Date: 5 October 2018
Ref: 1899 DA1 310 012
Council Ref: DA2018/0188

Response to request for additional information – Development application DA2018/0188, 65 Broadwater Quarry Road, Broadwater being described as Lots 1 & 8 DP1216612.

**Re: Broadwater Gittoes Quarry, Broadwater
Response to Council's Information Request**

COATES - CAPEX
3.0 x 6.0m M/F TOILET

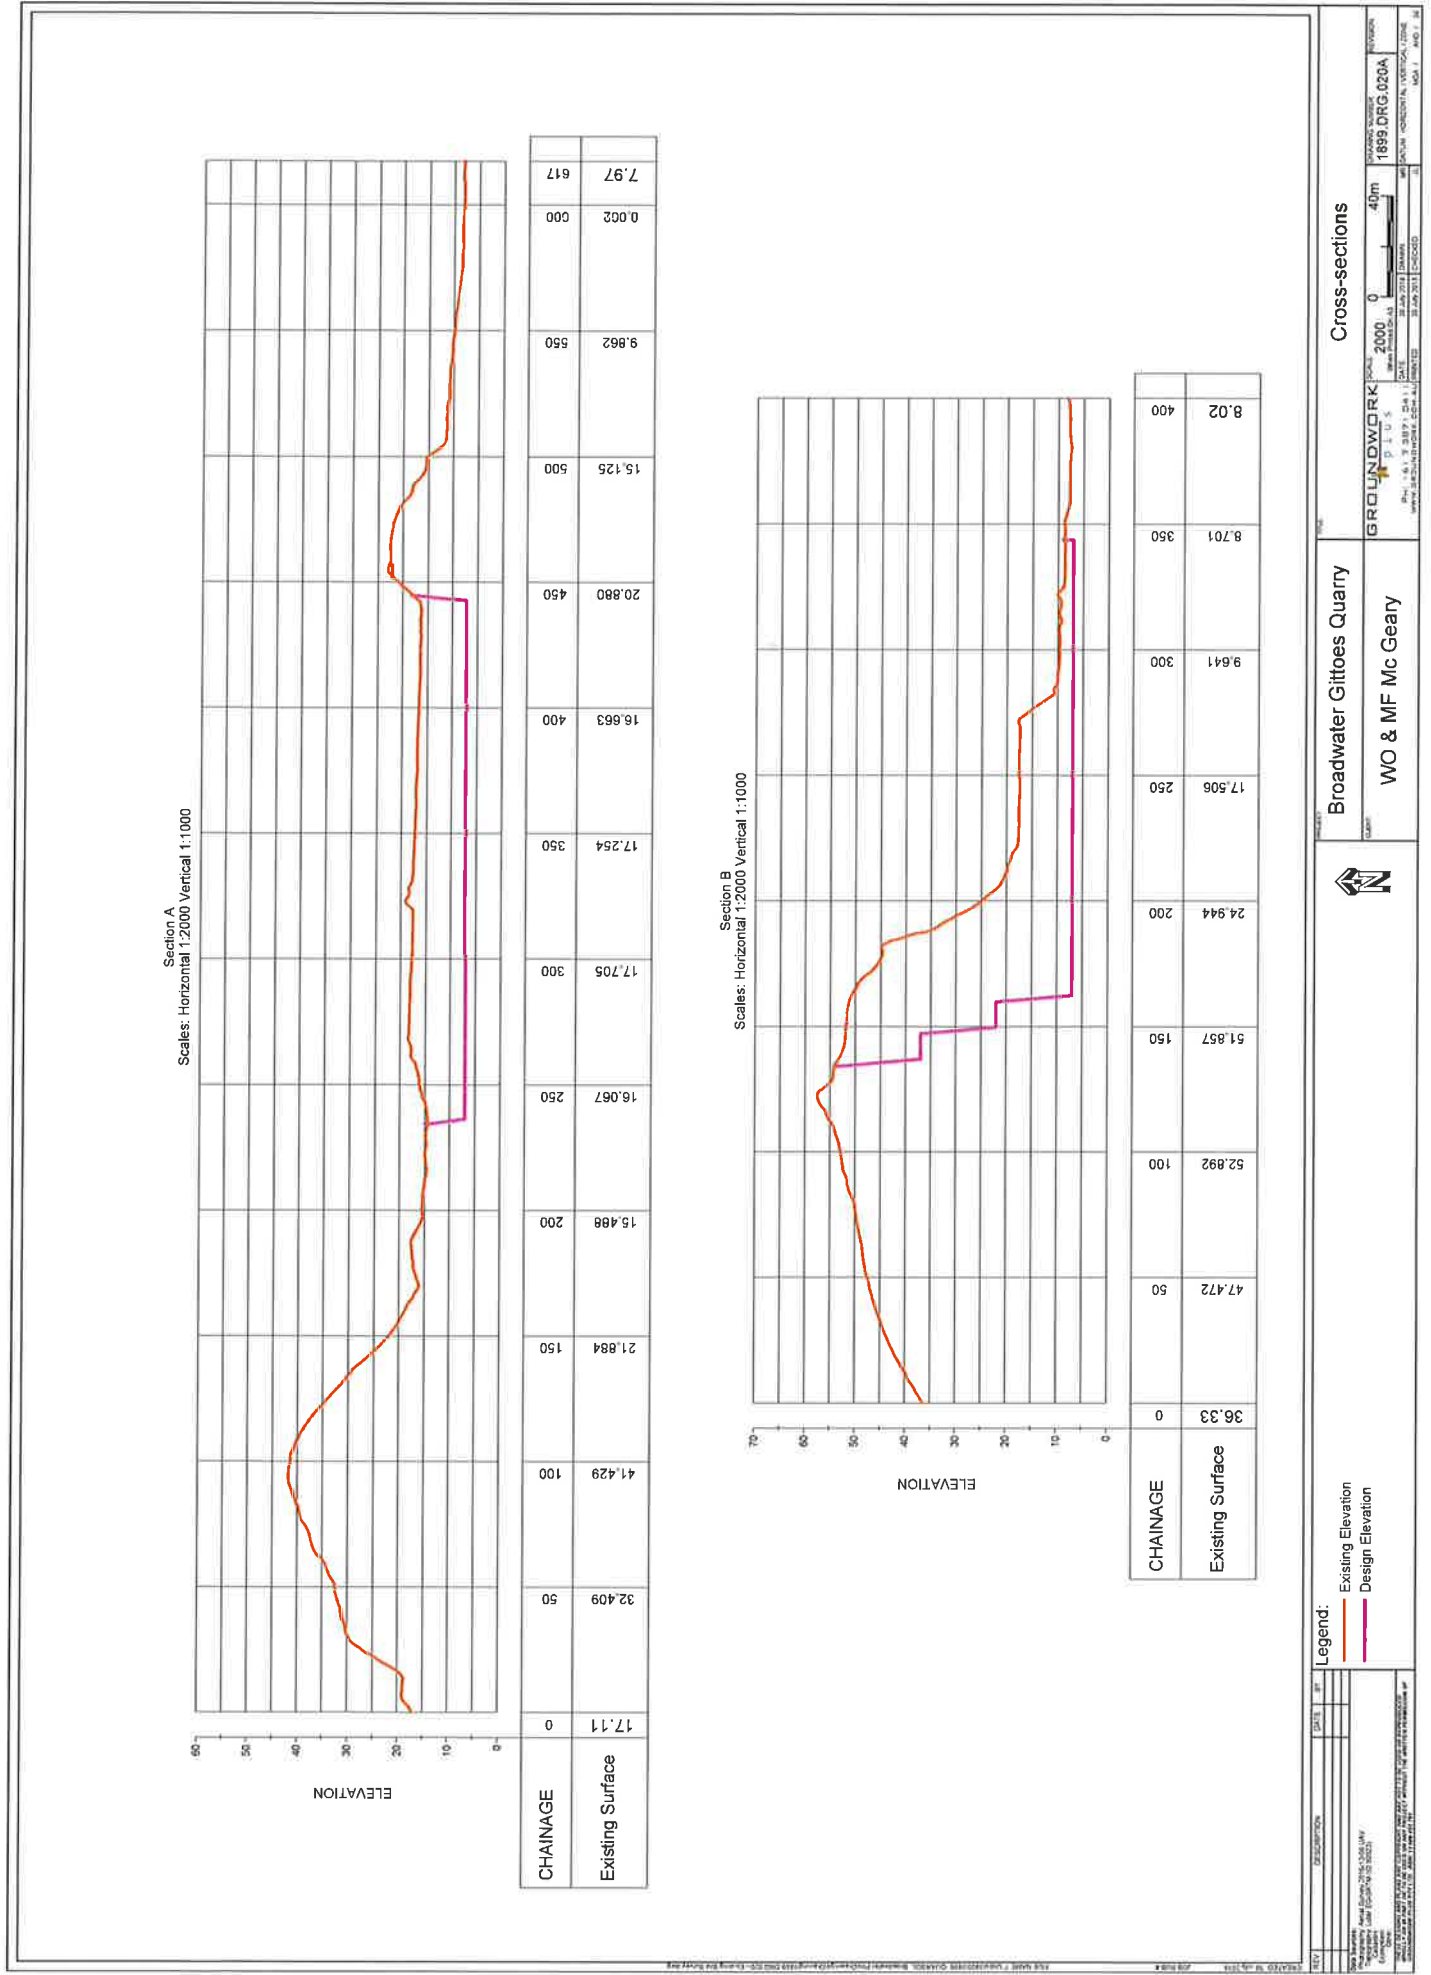
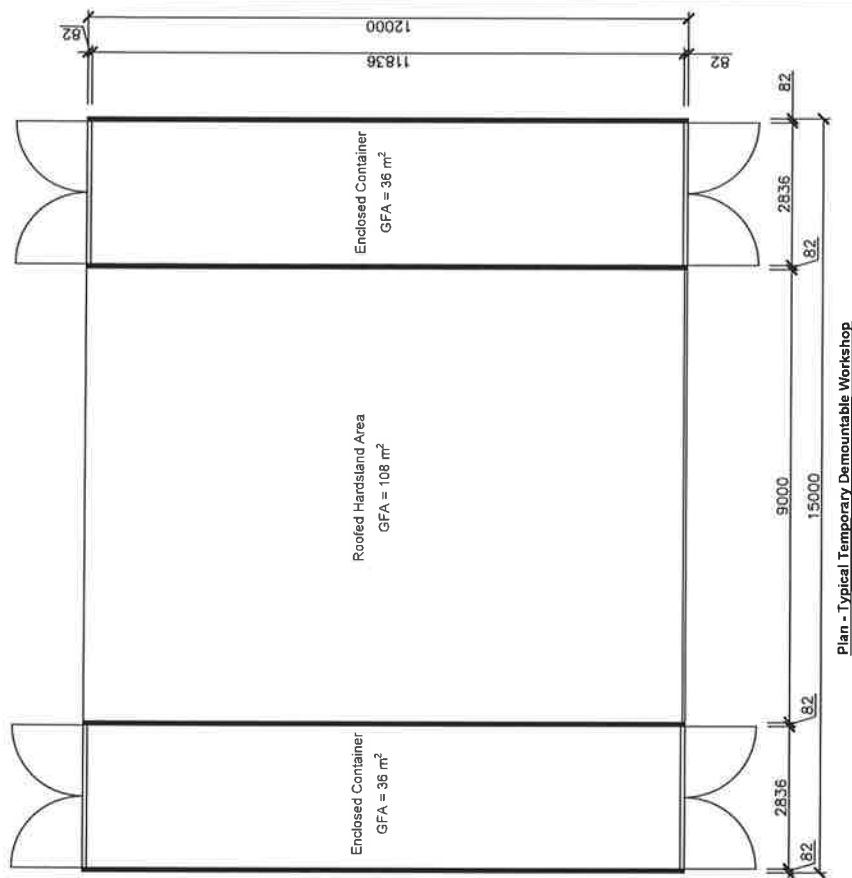
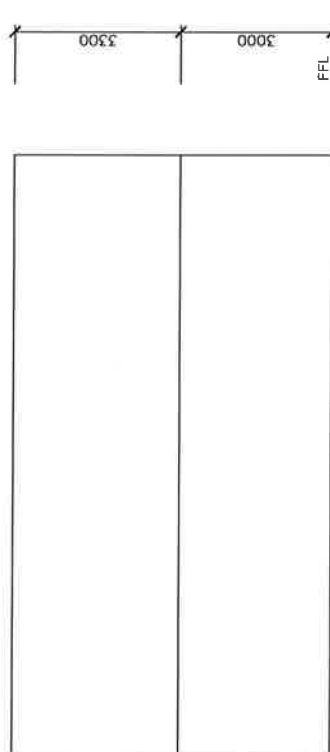
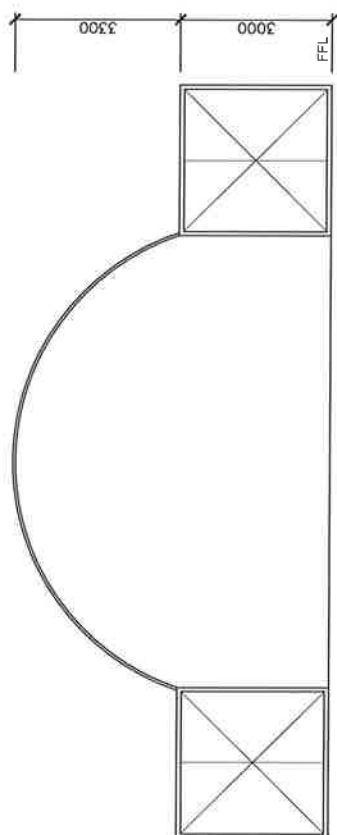
1. *Please confirm if consent is being sought for the following ancillary components (as outlined EIS section 3.2.1), and if so please provide plans including an updated site plan, floor plan and elevations;*
 - *Temporary demountable site office and ablution block*
 - *Rainwater tanks*
 - *Temporary workshop*
 - *Shipping containers for secure storage of materials and equipment*
 - *Temporary weighbridge (note the EMP 2.2.4 indicates a weighbridge will not be utilised).*
 - *A 100,000lt self bunded above ground fuel tank and/or any other chemical storage area.*

Consent is being sought for the ancillary components identified. The Conceptual Site Layout Plan has been revised (refer **Attachment 1 – Revised Conceptual Site Layout Plan**). Floor plans and elevations are provided for the proposed buildings including the Site Office, Toilets and Workshop (refer **Attachment 2 – Floor Plans and Elevations**). All those buildings and structures are temporary relocatable buildings. Shipping containers form part of the Workshop and any chemical storage area would be contained within the Workshop. Rainwater tanks are shown on the Conceptual Site Layout Plan. The Self Bunded Above Ground Fuel Tank is shown on the Conceptual Site Layout Plan, it is not a structure or a building and is also temporary and relocatable. It is confirmed that a weighbridge is not proposed and a weighbridge is no longer shown on the Conceptual Site Layout Plan.
